July 17, 2008

RE: NVS-213aan, PE08-029

EF CROSSMEMBER DESIGN CHANGE (EO NO: N3830284)

HYUNDAI'S RESPONSE TO PE08-029

DESCRIPTION OF CROSSMEMBER DRAIN HOLE IMPROVEMENT

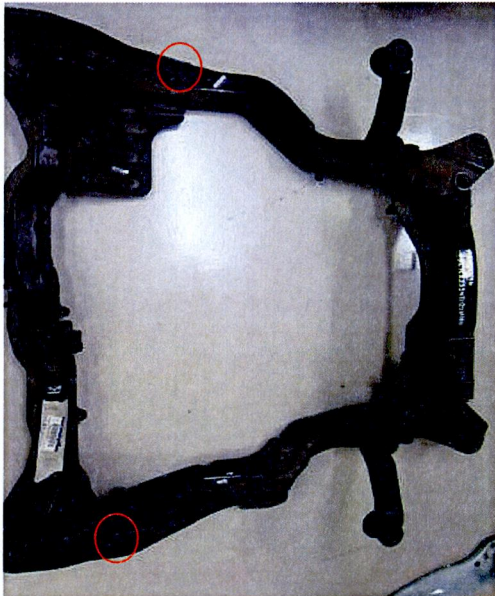
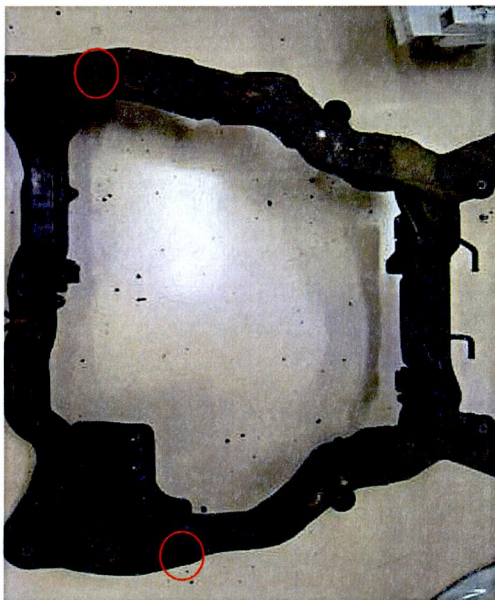
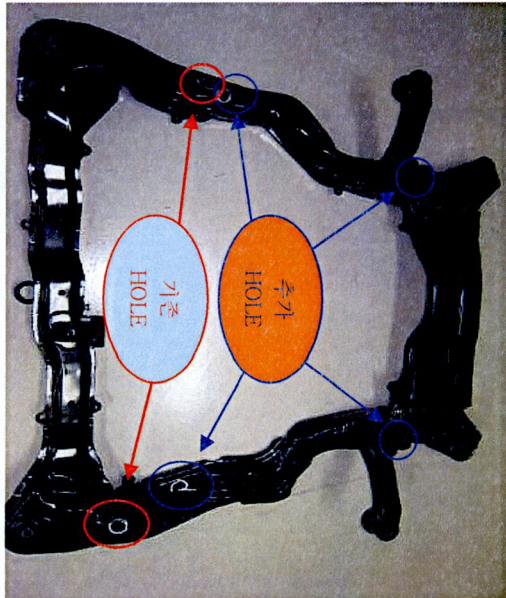
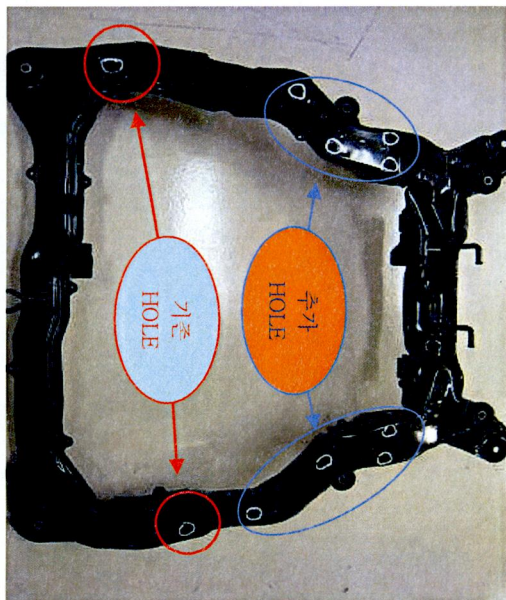
| BEFORE AND AFTER | | UPPER PANEL | | LOWER PANEL | | NUMBER OF HOLES |
|------------------------|--|--|---|-------------|--|-----------------|
| 개선前 ORIGINAL |  |  | <div>기존 HOLE UPR 2EA LWR 2EA (TOOL'G HOLE)</div> <div>ORIGINAL HOLES</div> | | | |
| 개선後 COUNTER MEASURE |  |  | <div>기존 HOLE UPR 2EA LWR 2EA 추가 HOLE UPR 4EA LWR 8EA</div> <div>ADDED HOLES</div> | | | |

| LINE | DATE | DESCRIPTION OF CHANGE | REMARK |
|---------------|------------|---|--------|
| ASSEMBLY LINE | 11/20/2003 | - CROSSMEMBER AND SIDEMEMBRR ADDED 12 DRAIN HOLES EACH (UPPER : $\Phi 15$ mm - 4EA, LOWER : $\Phi 12$ mm- 4EA, $\Phi 15$ mm - 4EA) | |

EF CROSSMEMBER CORROSION PATH

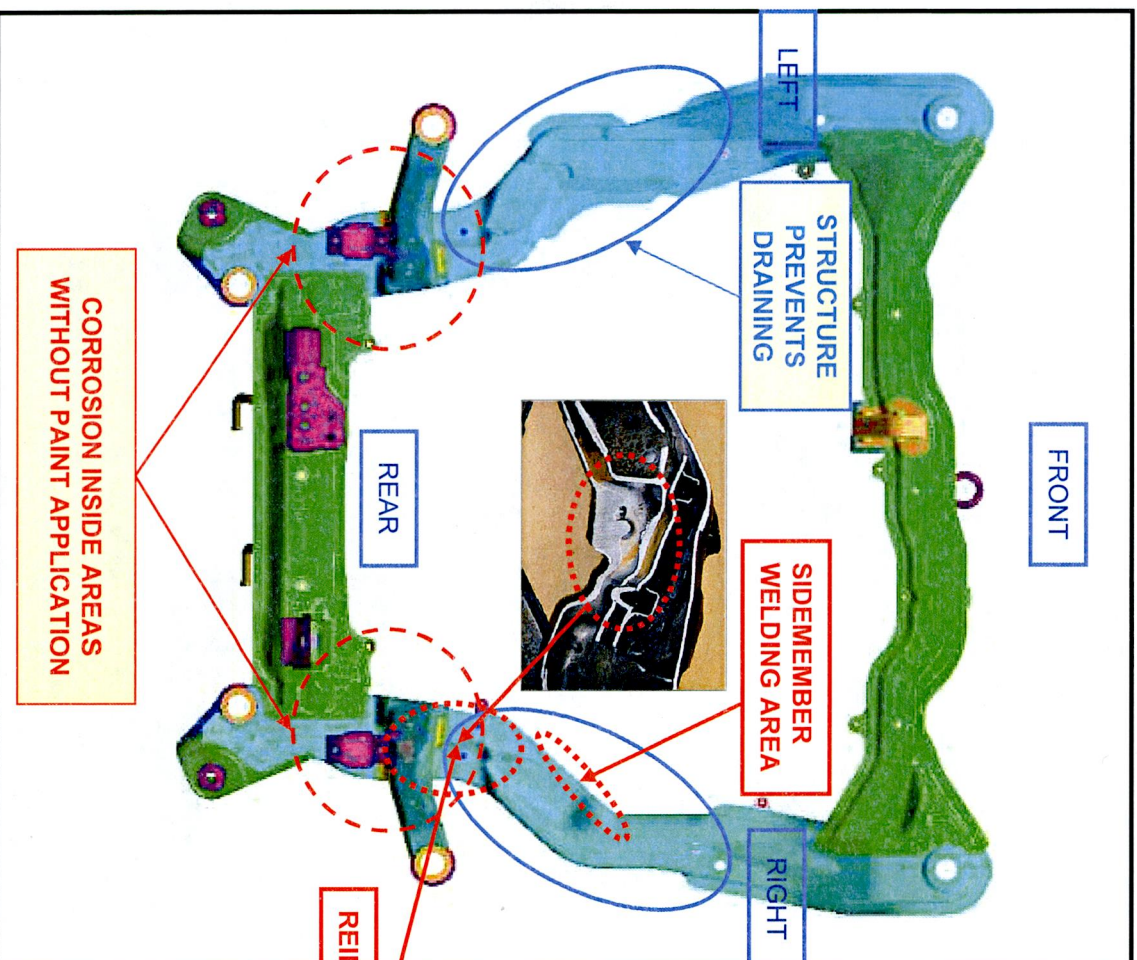
- DURING WINTER DRIVING ROAD SALT
MAY DEPOSIT NEAR REINFORCEMENTS
INSIDE THE CROSSMEMBER**
- AREAS OF CORROSION**
- SIDE MEMBER WELDING AREA**
 - AREA WHERE REINFORCEMENTS MAY
PREVENT ANTI-CORROSION TREATMENT**
- REINFORCEMENT PANEL AREA**
